Well Name: UNCLE CHES 2116 FED COM	Well Location: T20S / R35E / SEC 21 / SESE / 32.5525766 / -103.4556807	County or Parish/State: LEA / NM
Well Number: 234H	Type of Well: OIL WELL	Allottee or Tribe Name:
Lease Number: NMNM132079	Unit or CA Name:	Unit or CA Number:
US Well Number: 300254734000X1	Well Status: Approved Application for Permit to Drill	Operator: MATADOR PRODUCTION COMPANY

Notice Of Intent

Type of Submission: Notice Of Intent	Type of Action APD Change
Date Sundry Submitted: 07/06/2020	
Disposition: Approved	Disposition Date: 12/03/2020

WELL LOCATION AND ACREAGE DEDICATION PLAT

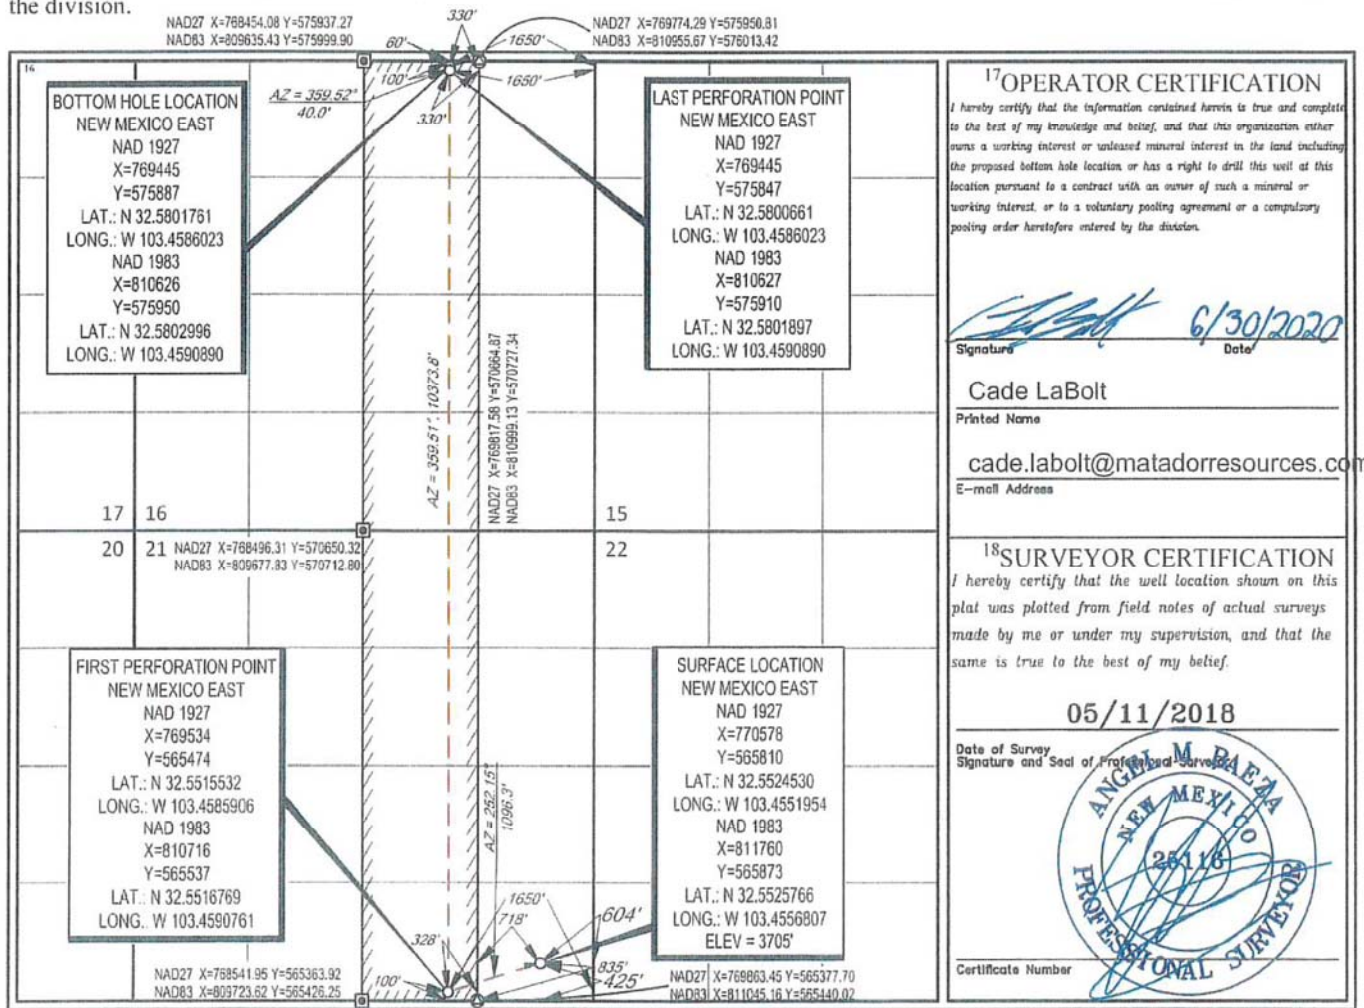
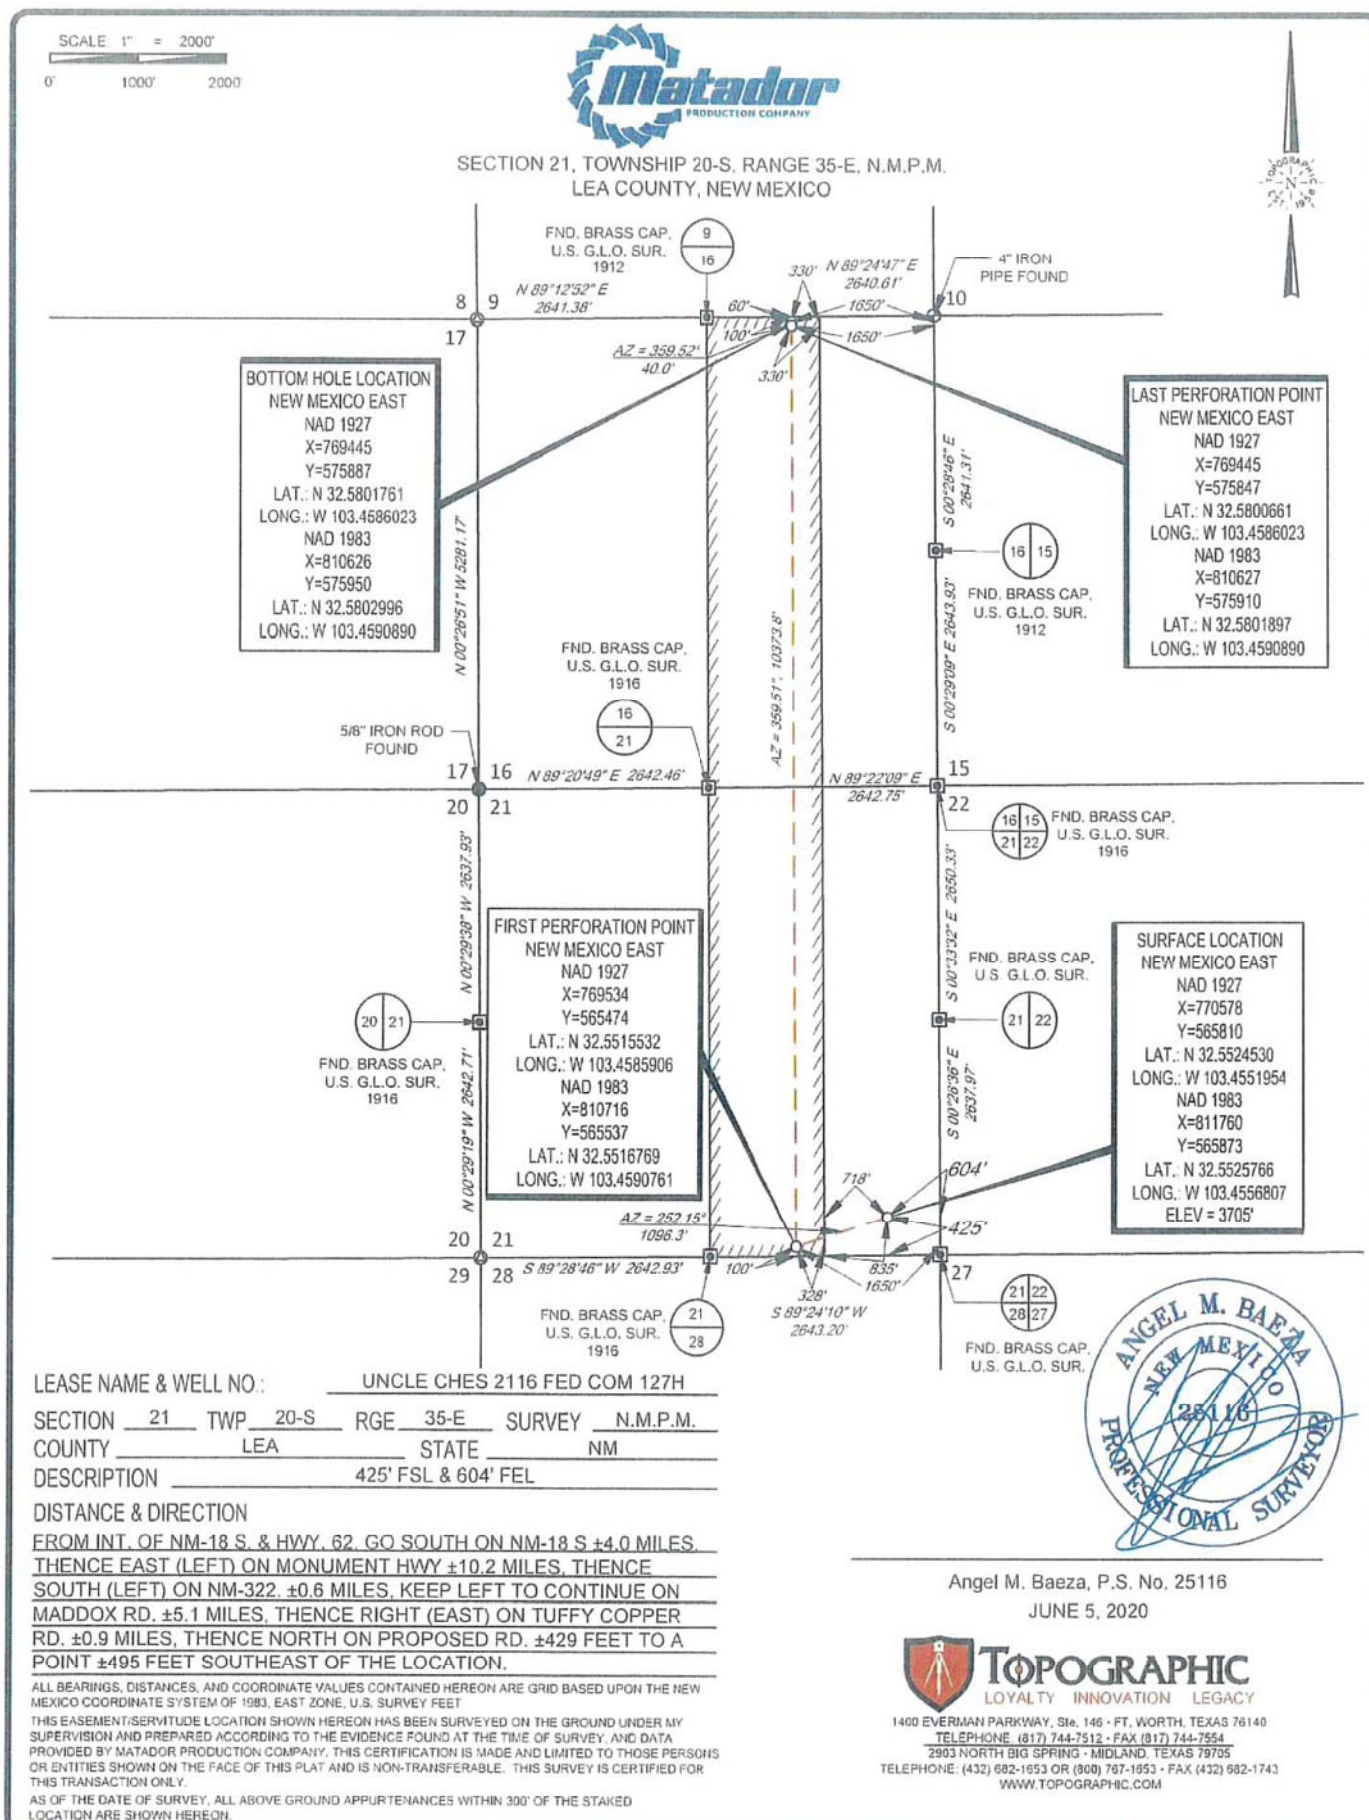
Remarks: JUANA MEDRANO:APPROVAL:2020-07-06 BLM Bond No. NMB001079 Surety Bond No. RLB0015172 Matador requests the name of this well to be changed from Uncle Ches 2116 Federal Com 234H (API 30-025-47340) to Uncle Ches 2116 Fed Com 127H. Please see the attached C102 to revise the SHL of Matador's Uncle Ches 2116 Fed Com 127H from 425' FSL and 604' FEL of Sec. 21 T20S R35E to 425' FSL and 604' FEL of Sec. 21 T20S R35E. This proposed SHL move lies within the approved well pad location footprint covered in Environmental Assessment DOI-BLM-NM-P020-2019-0741-EA. Matador requests the BHL be revised from 240' FNL 331' FEL of Sec. 16 T20S R35E to 60' FNL and 1650' FEL of Sec. 16 T20S R35E. The BHL given represents the terminus of the well. The last perforation point will be 100' FNL and 1650' FEL of the referenced spacing unit comprising the W2E2 of Sections 21 and 16 of T20S R35E. Matador requests for this well to be revised and placed into the Featherstone; Bone Spring (Pool Code 24250) (Oil). Matador requests the OPTION to amend the casing and cementing design per the drill plan attached hereto. Please contact Blake Hermes at 972-371-5485 for any questions with regards to the drill plan or well design. Sundry - Name Change from Uncle Ches Fed Com 234H to Uncle Ches Fed Com 127H and BHL Change - Approved by Rachel Ijabiken on 11/2/2020. No additional COA is required RACHEL IJABIKEN:APPROVAL:2020-11-02 Sundry - Name change from Uncle Ches Fed Com 234H to Uncle Ches Fed Com 127H and BHL change- Approved by Rachel Ijabiken. No Additional COA is required. Approved by Mandala 11/16/2020; Surface good 12/02/2020 Same COAs JLR. Approved by Ty Bryson 12/03/2020. PRISCILLA PEREZ:APPROVAL:2020-12-14 Matador Resources is submitting a subsequent sundry after receiving verbal approval from Mandela on 12/08 for the OPTION to amend the mud program on the intermediate hole section for the Uncle Ches 2116 Fed Com #127H (30-025-47340). All previous COA?s still apply. Please find supporting documentation attached and contact Jordan Ellington at 972-619-1263 for any questions.

UL or lot no.	Section	Township	Range	Lot Idn	Feet from the	North/South line	Feet from the	East/West line	County
P	21	20-S	35-E	-	425'	SOUTH	604'	EAST	LEA

UL or lot no.	Section	Township	Range	Lot Idn	Feet from the	North/South line	Feet from the	East/West line	County
B	16	20-S	35-E	-	60'	NORTH	1650'	EAST	LEA
